189 KEEFER STREET (COMPLETE APPLICATION)
DE415496 - ZONE HA-1A

DEVELOPMENT PERMIT STAFF COMMITTEE MEMBERS

DEVELOPMENT PERMIT STAFF COMMITTEE RECOMMENDATION: APPROVE

solitera
 Group of Companies
 Project: **KEEFER & MAIN ST.
 VANCOUVER, B.C.**
 Drawing No: **LEVEL 1 (MAIN FLOOR)
 PLAN**

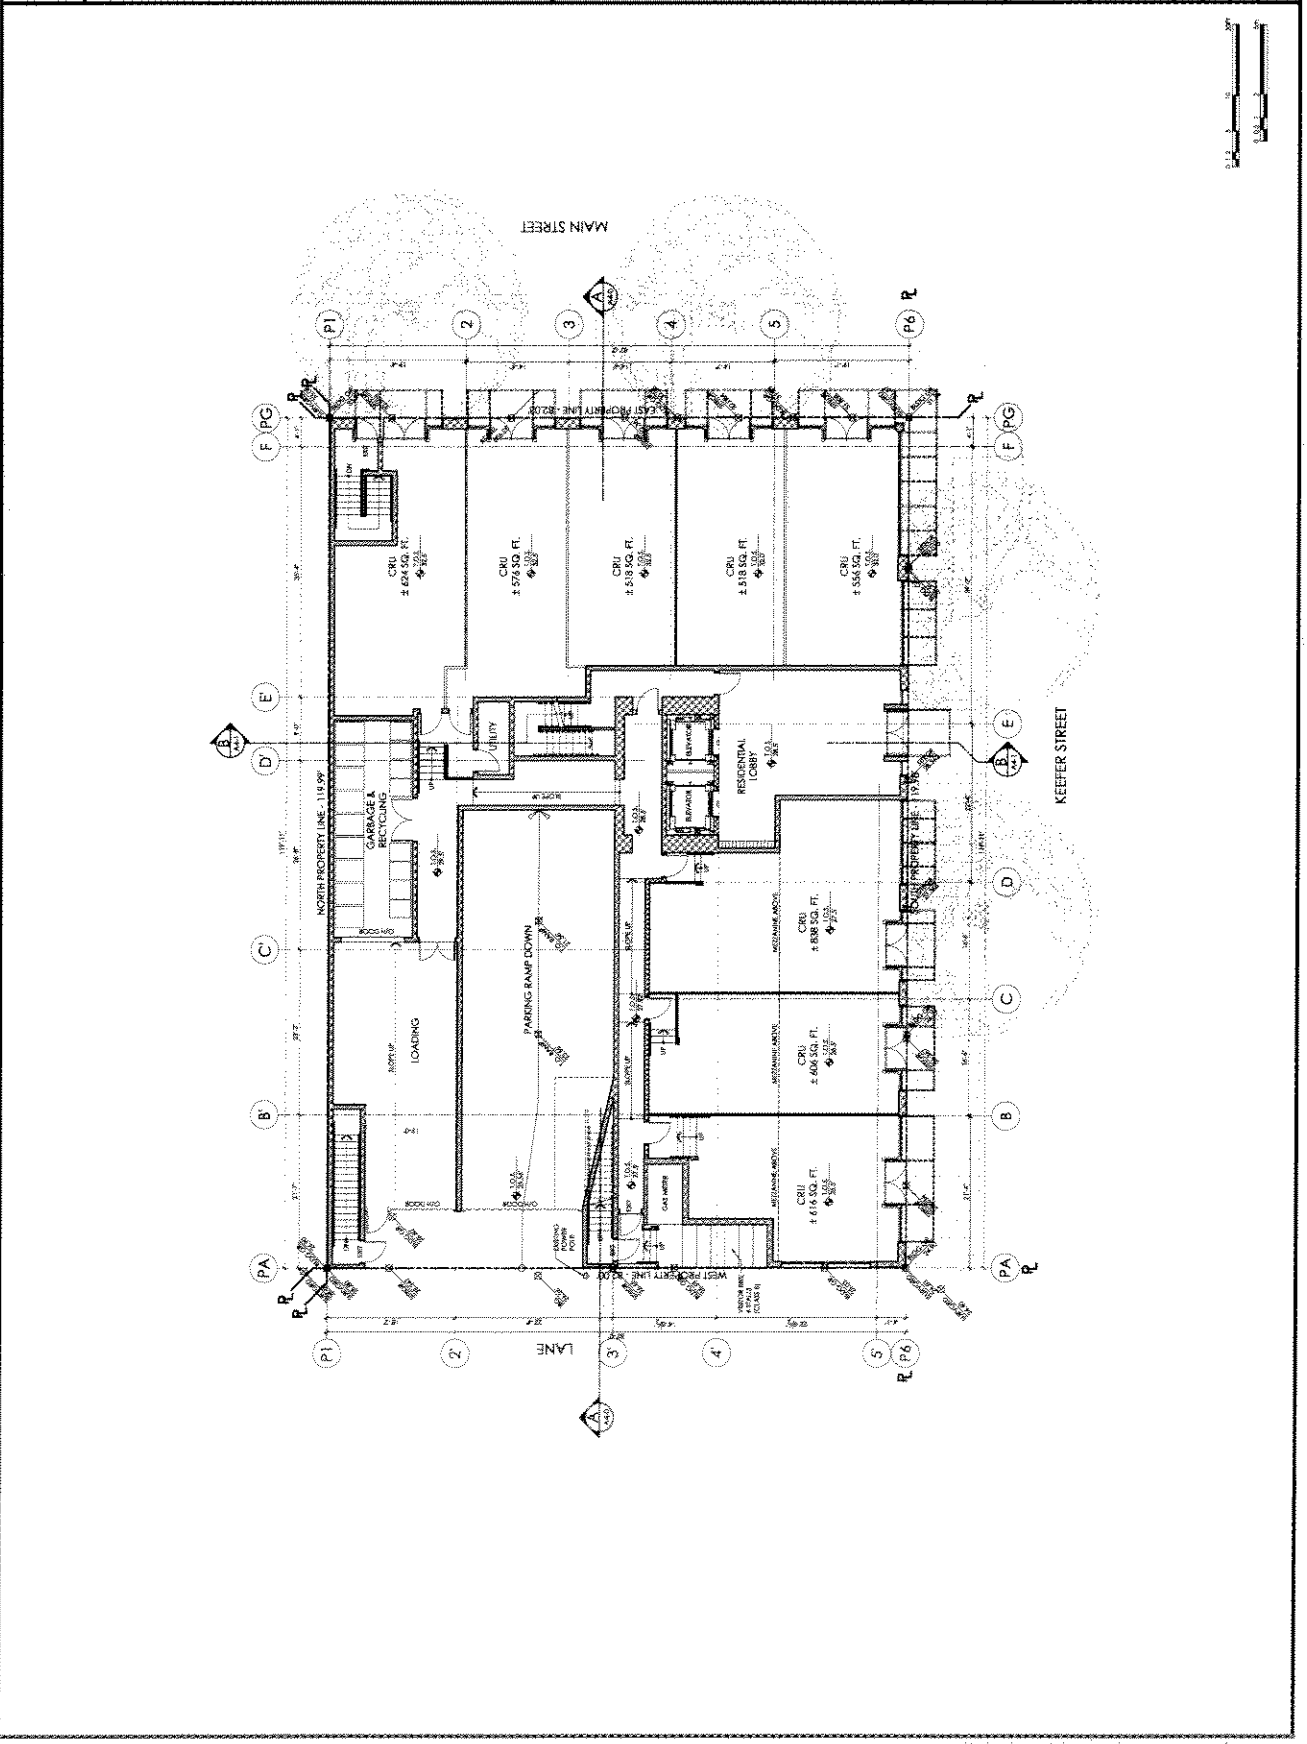
- a) Shift the 6 Class B Bicycle spaces to locations on Main and Keefer Streets, adjacent to the residential lobby and Commercial Retail Units (CRU's) they serve, and consistent with Engineering bicycle rack requirements;

- b) Replace that bicycle alcove with a straight wall, and if possible, and Commercial Retail Unit (CRU) window onto the lane. Consider adding a CRU door directly to the lane;

- d) North of Grid #3, continue the walls and overhead doors as a flush condition at 3.28 ft minimum as per Section 4.6.1 of the HA-1A District Schedule, and setback the wall of level 2 above to remove the covered overhang. Any doors required to swing toward the lane can swing into this 3.28 ft zone.

- e) Add street-quality lighting fixtures along the lane and in all the recessed areas, including the ramp and loading bays; and
- f) Add a decorative metal treatment to the overhead doors to add pedestrian scale and interest along the lane as per Section 5.5.2 of the HA-1A Design Guidelines.

Note to Applicant: The intent of the HA-1A Guidelines 4.3.2(d) and its 3.28 ft (1 m) setback is to eliminate door alcoves and any covered recesses which become Crime Prevention through Environmental Design (CPTED) issues along the lanes.

Drawing Title: **LEVEL 1 (MEZZANINE)
 PLAN**

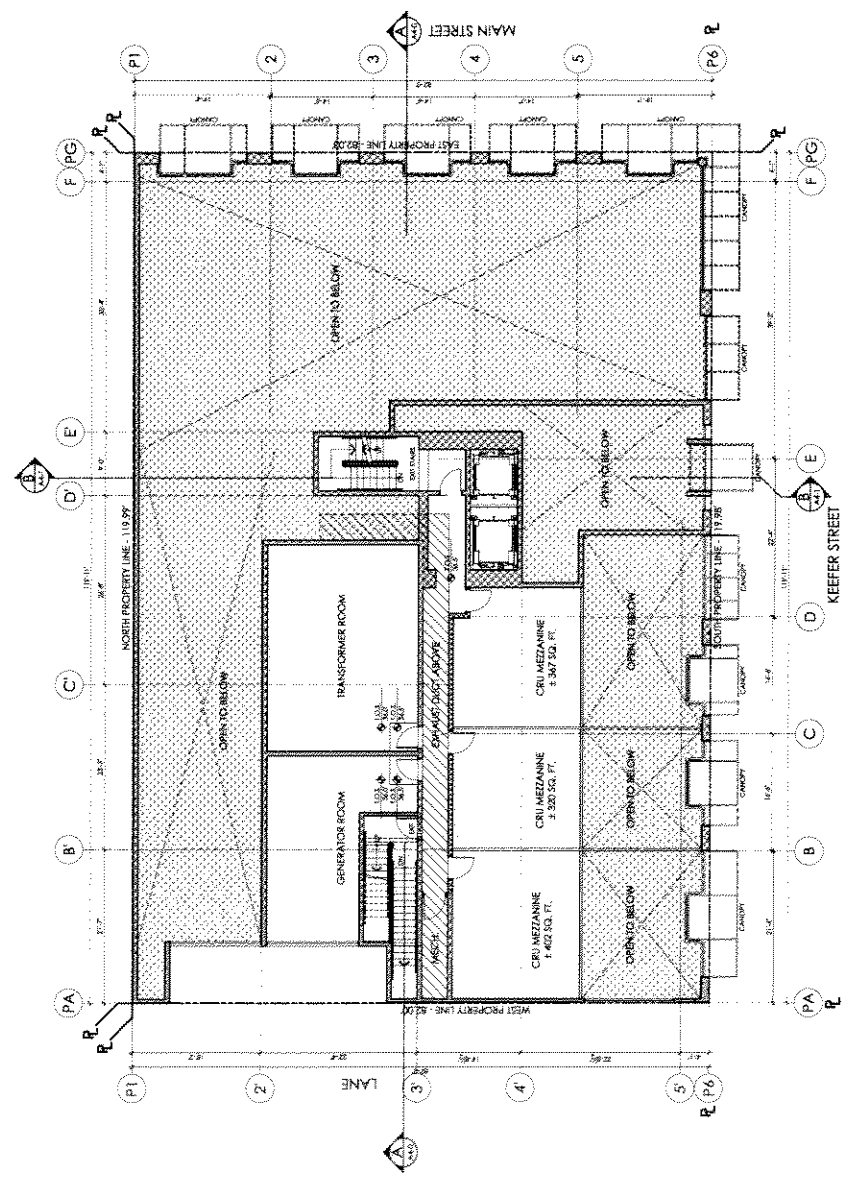
- c) Provide a letter from BC Hydro confirming the Mezzanine location of the transformer room is acceptable. Alternatively, incorporate a pad mounted transformer (PMT), and its required clearances, if ultimately required at grade, facing the lane and north off the corner as much as possible;

Drawing No: **LEVEL 7
 PLAN**

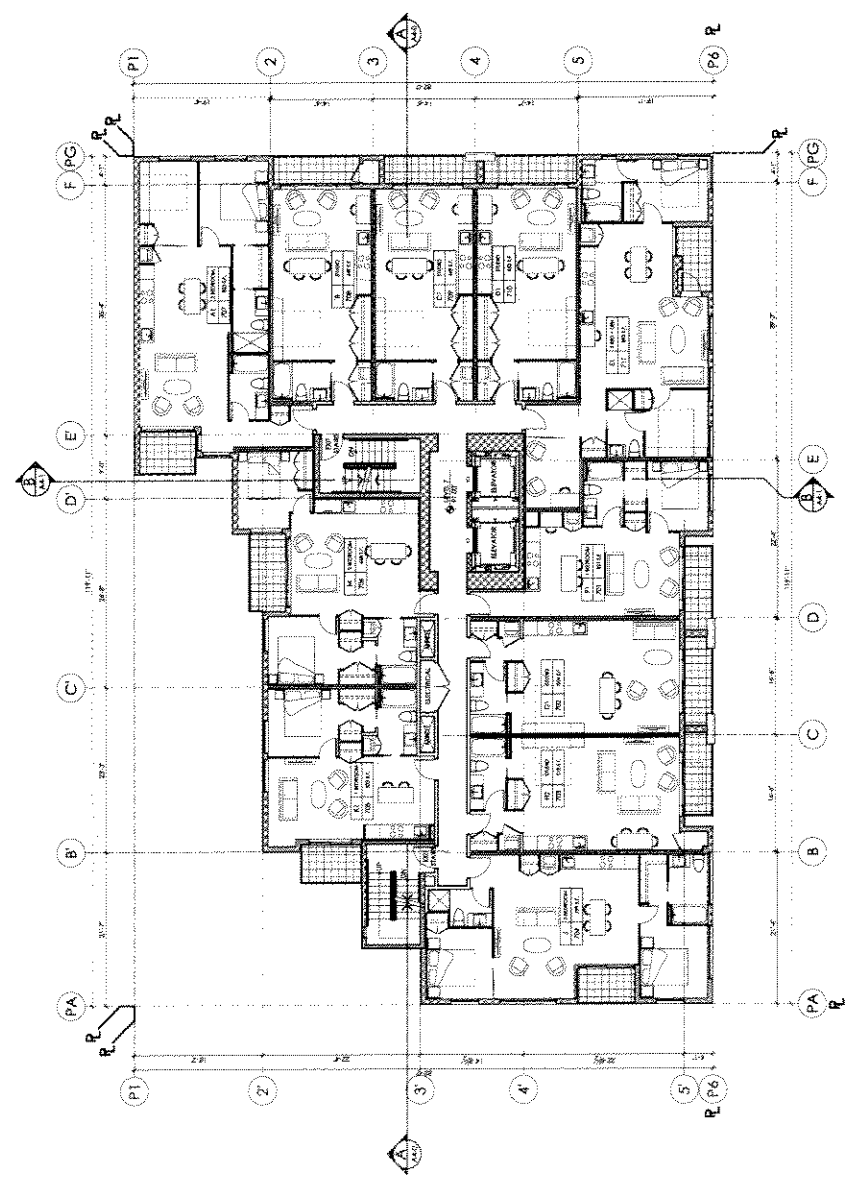
- ii. Delete or change the wood trellis elements to a metal and glass treatment thereby maintaining consistency with the upper stories. At level 7 on Keefer St, return the piers at grids C & D as full boxes to maintain consistency with the floors below;

LEVEL 10 (ROOF DECK) PLAN

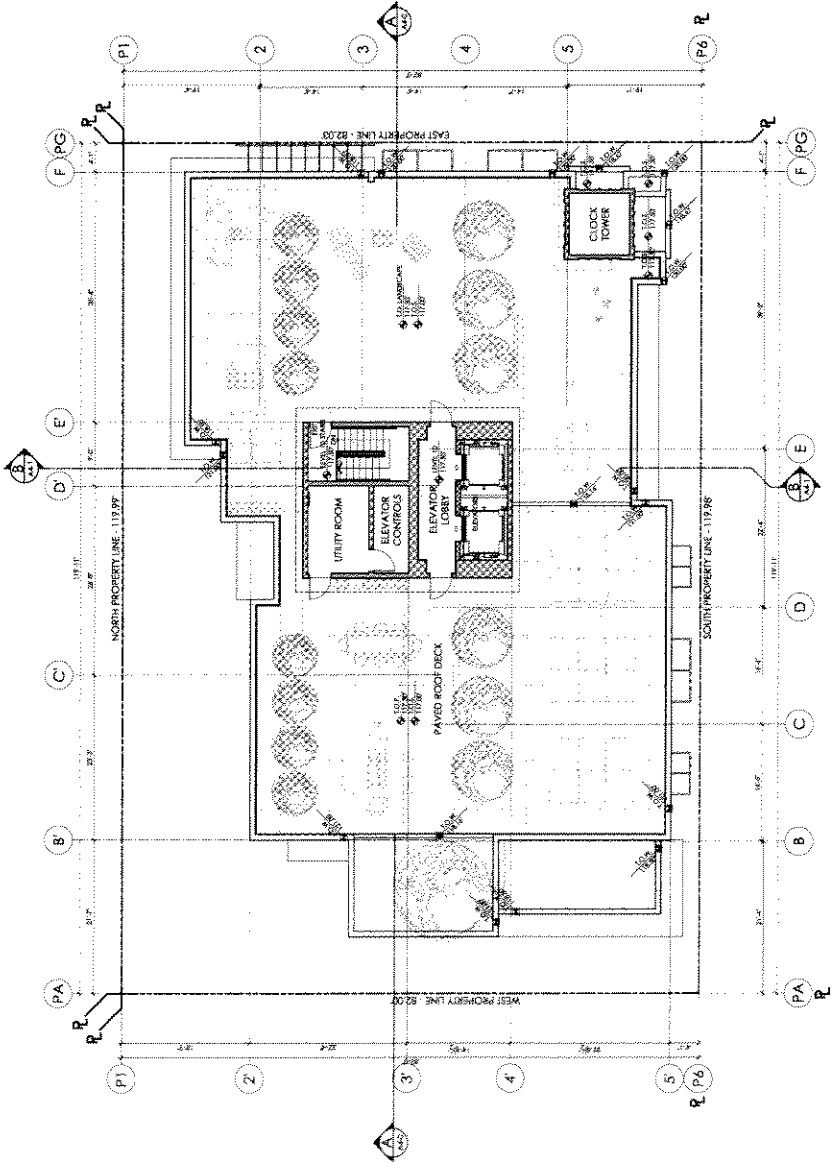
- d) Consideration of diverse materials other than painted concrete on the lower portions of the level 10 "roof deck" box, which will be visible from taller buildings in vicinity and is a very active roof garden design, deserving of diverse and quality finishes;

WEST ELEVATION
 DECEMBER 2011
 1/8" = 1'-0"
 3'-0" = 1'-0"

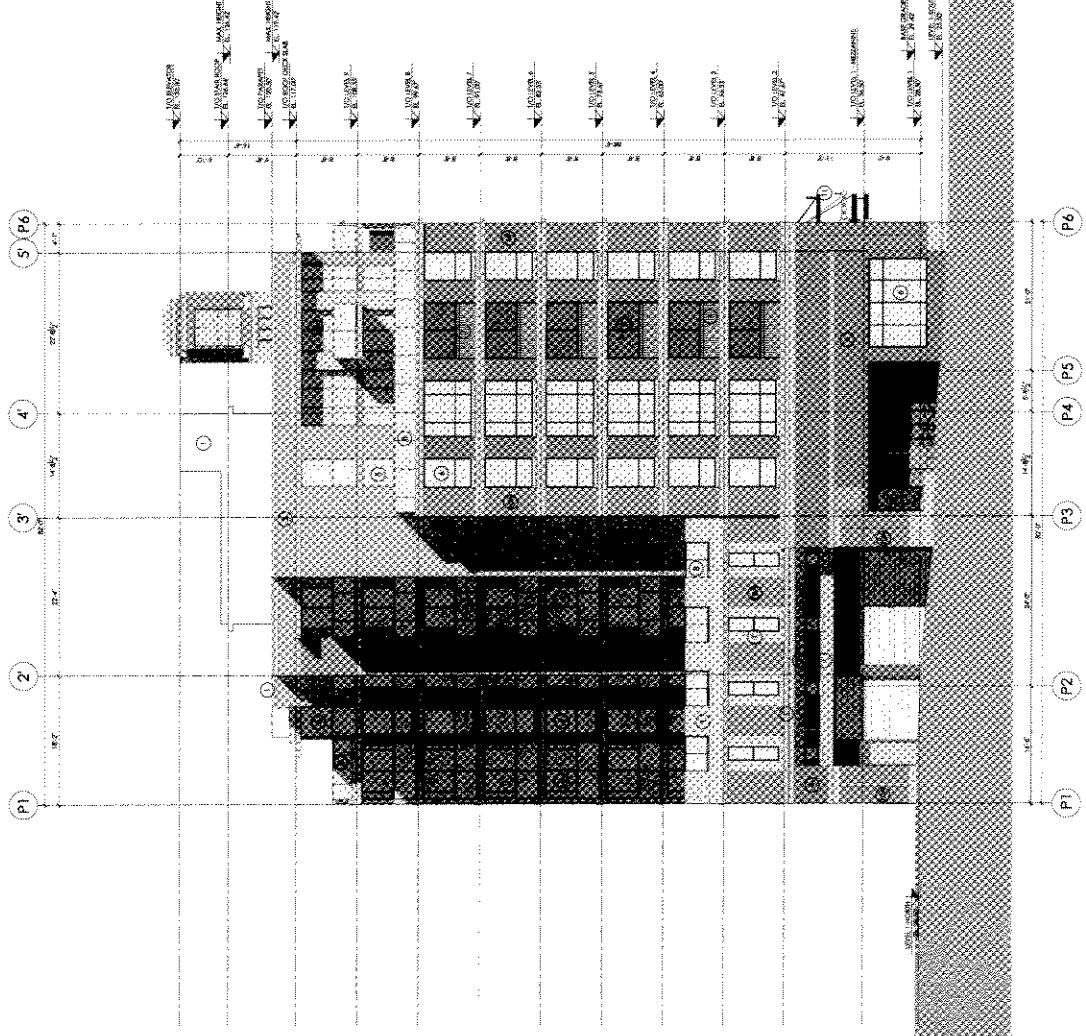
- a) Continuation of brick material #10 across the entire west façade located below level 8, from the southwest corner to grid #3, and turn the corner back to the stair enclosure wall. Also use Brick #10 along the entire lower lane façade located below level 2;
